Docket Item # 12 & 13  
BAR CASE # 2010-0182 & 0192

BAR Meeting  
July 21, 2010

**ISSUE:** Permit to Demolish/Encapsulate & Alterations

**LOCATION:** 804 Duke Street

Figure 5: Proposed floor plans

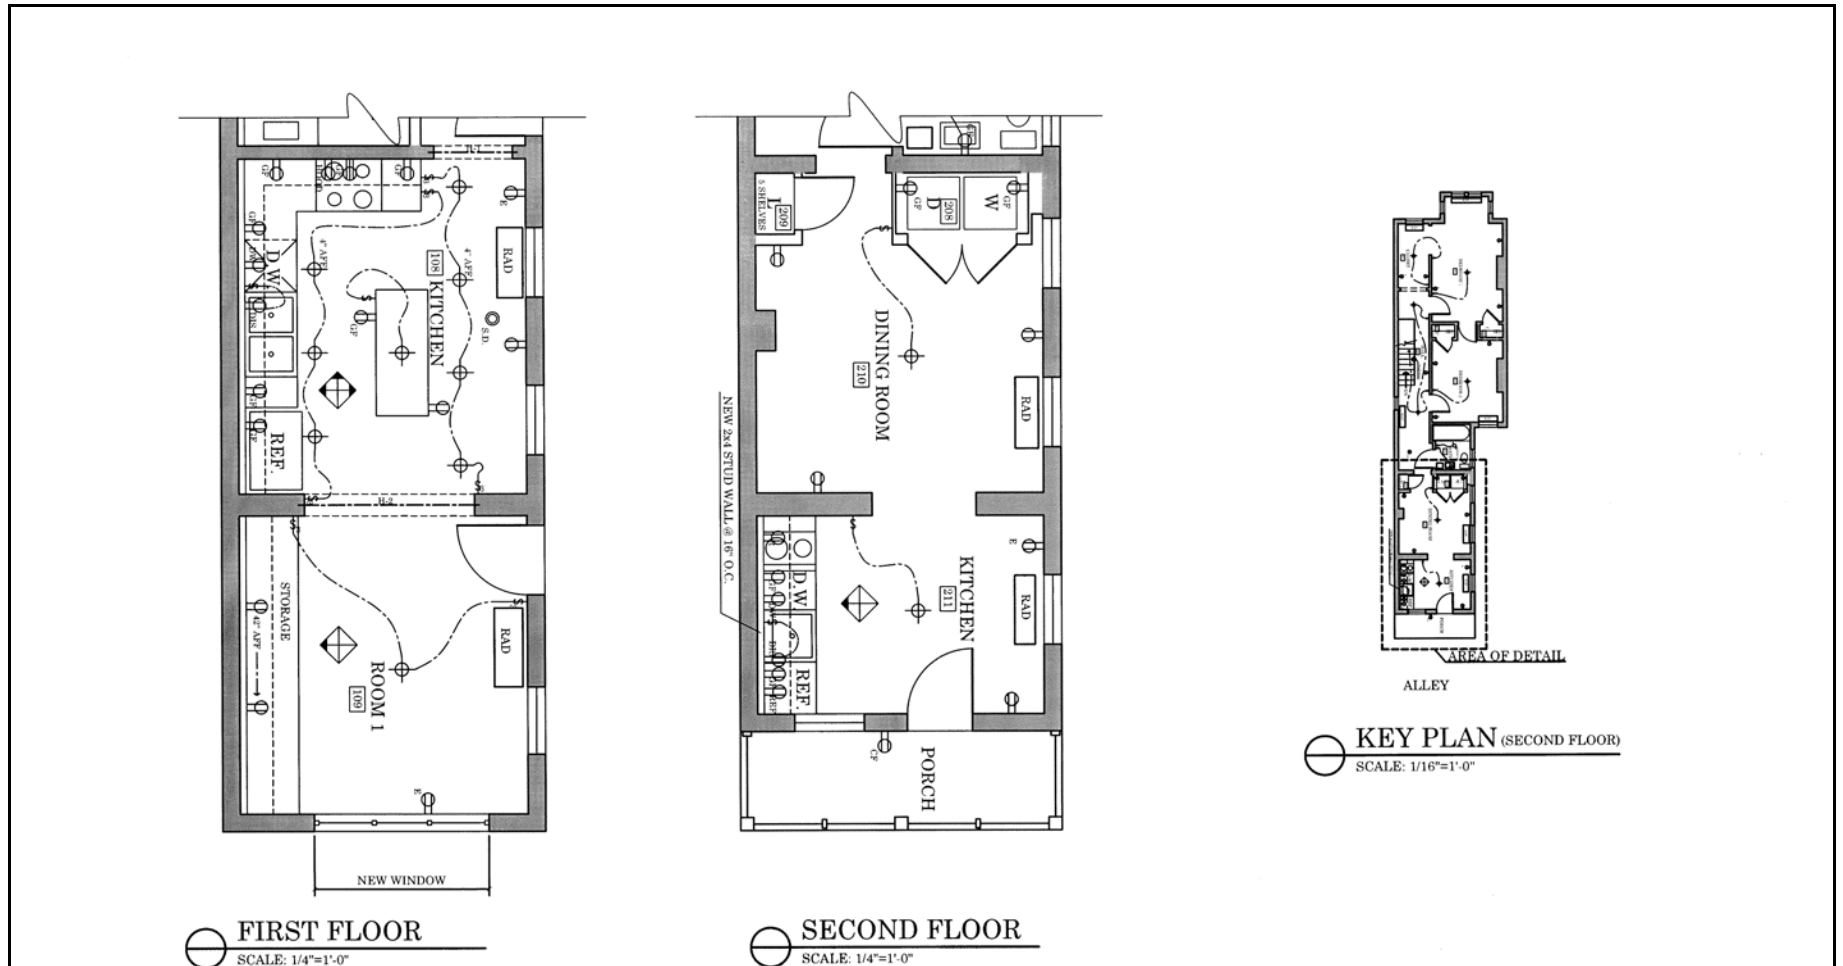
In the opinion of Staff, none of the criteria are met and the Permit to Demolish/Encapsulate should be granted. The pressure treated wood stair likely dates from the mid-to-late a 20<sup>th</sup> century and is not original to the house. Furthermore, the enlargement of the window opening on the rear elevation is relatively minor in scale and limited in visibility.

Staff commends the applicant for the removal of the non-historic rear stair and for uncovering the existing historic window on the east elevation. Although the new windows proposed on the rear elevation are not single glazed, they are true-divided-lights which is an acceptable window type identified in the *Design Guidelines*. The light configuration proposed by the applicant, two-over-two, is the only light pattern where the true-divided-light muntin width can be historically appropriate – as these will be. Staff believes the tri-partite grouping of the windows is appropriate for this secondary visible location, as ganged windows were common on late Victorian buildings.

Staff recommends approval of the application as submitted.
